Seismic Study – McLeod Tower

Seismic Evaluation Report

Palomar Health McLeod Tower (Building C)

Job No. 17-S023B

DETAIL 10

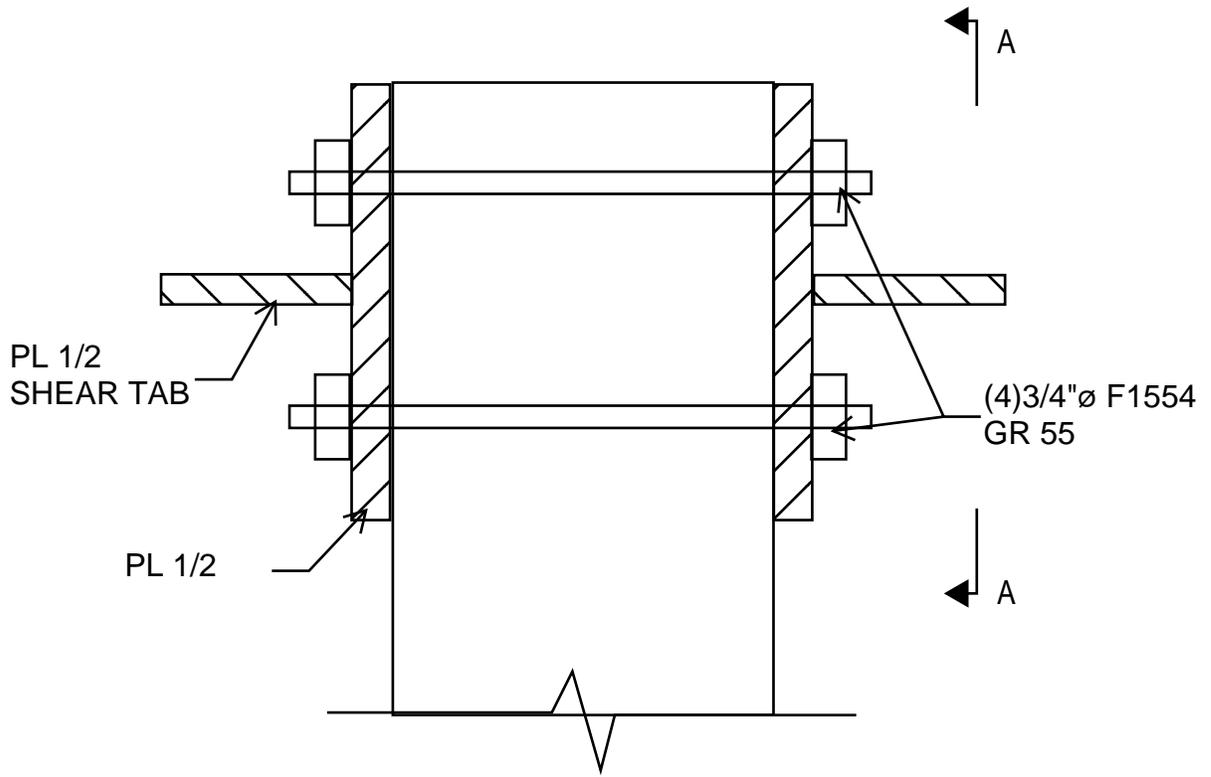
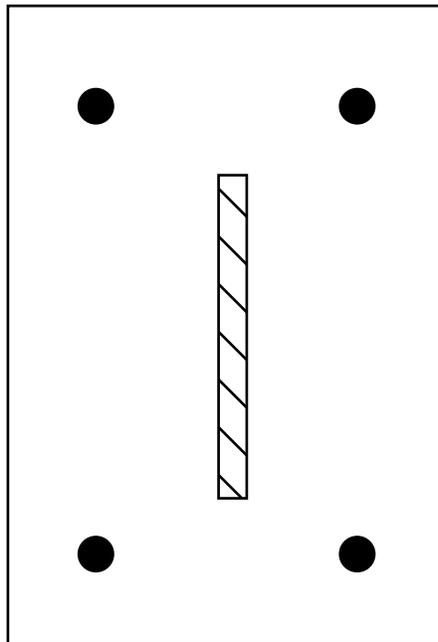
Recommended Carbon Fiber Wrapping at Existing
Wall Jamb to Increase Confinement (Conceptual)
